City of Portland, Maine – Building or Use Permit Application 389 Congress Street, 04101, Tel: (207) 874-8703, FAX: 874-8716

**Minor/Minor Site Review for New Detached Single Family Dwelling,
All Purpose Building Permit Application**

REASON FOR PERMIT: To Amend permit # 001252 / adding 18' x 18' ~~at the rear~~

REASON FOR PERMIT: 18' x 18' addition

FLOOR PLAN
1/4" = 1'-0"

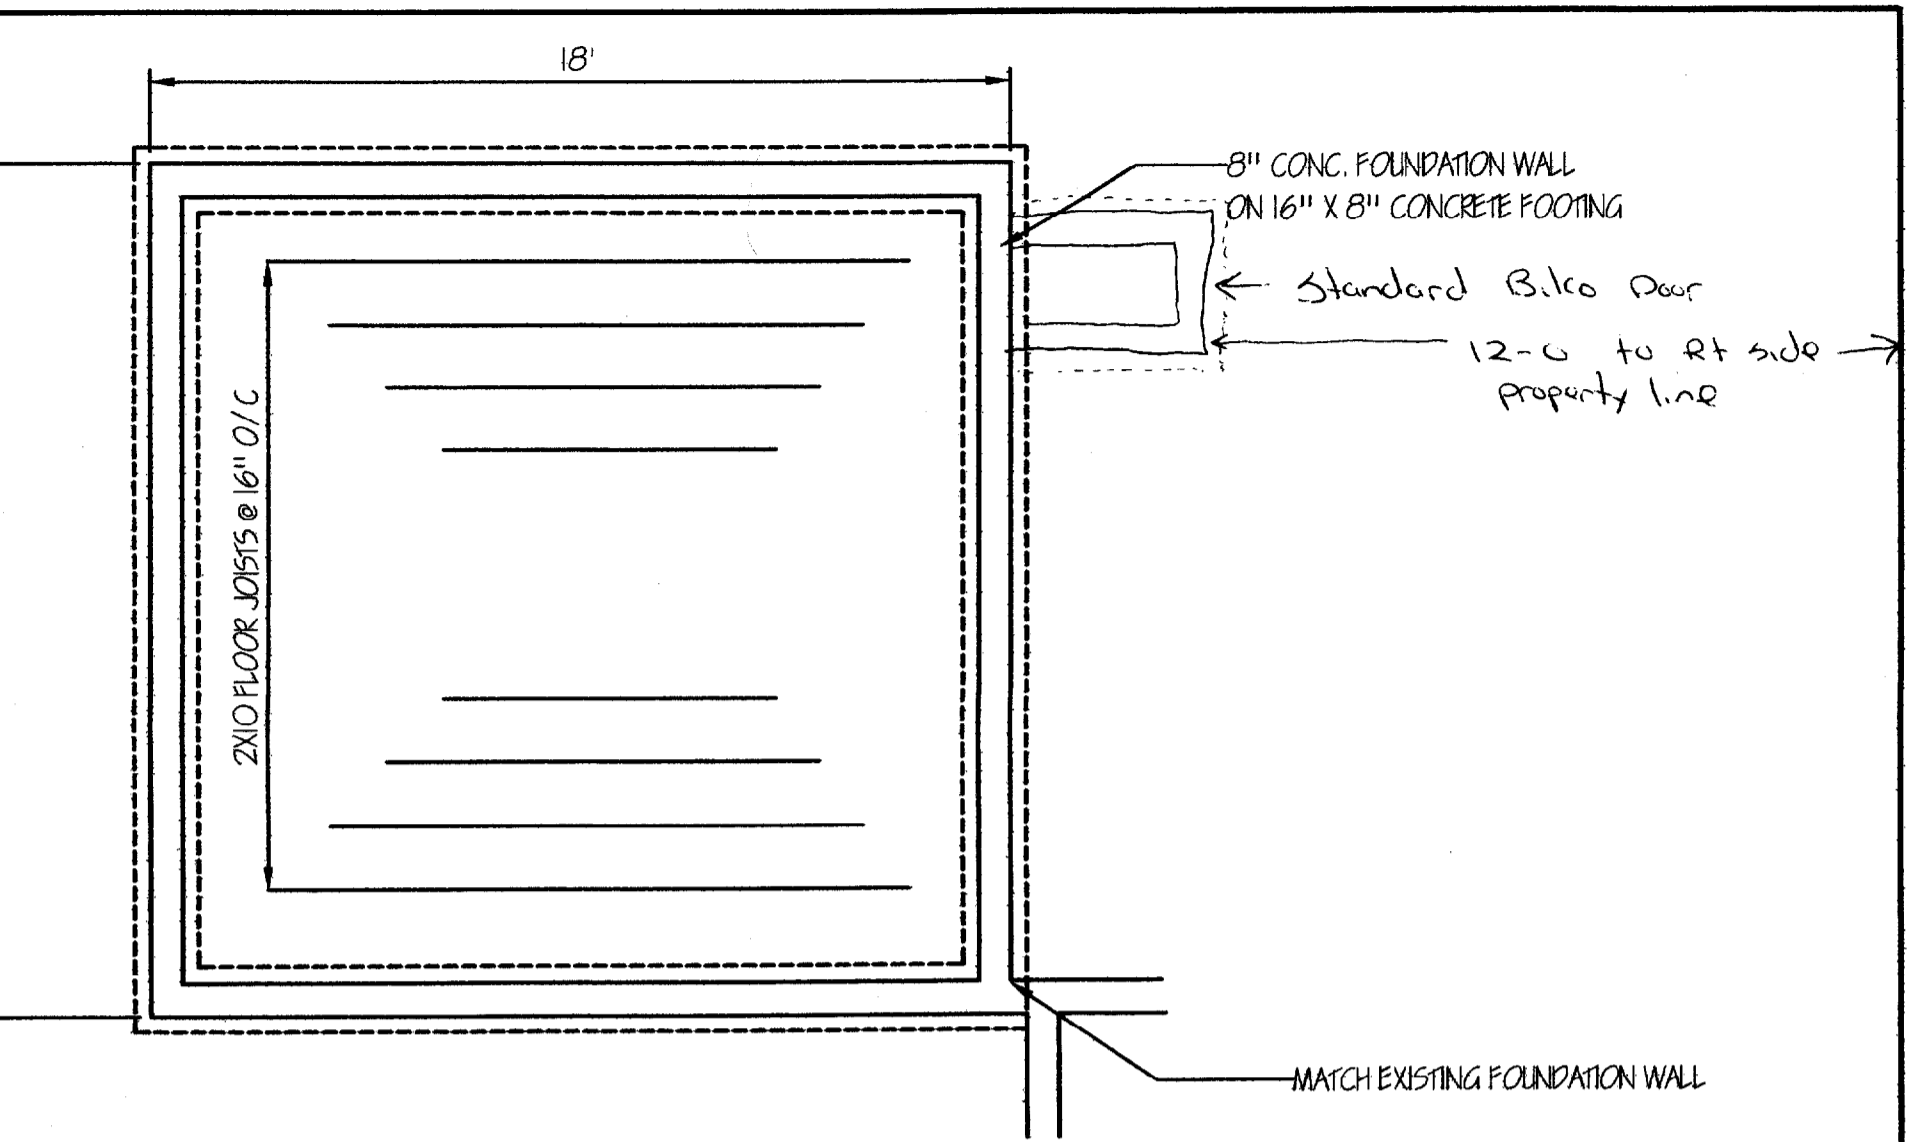
*Sleeping room
rescue or egress window
sec. 1010.4*
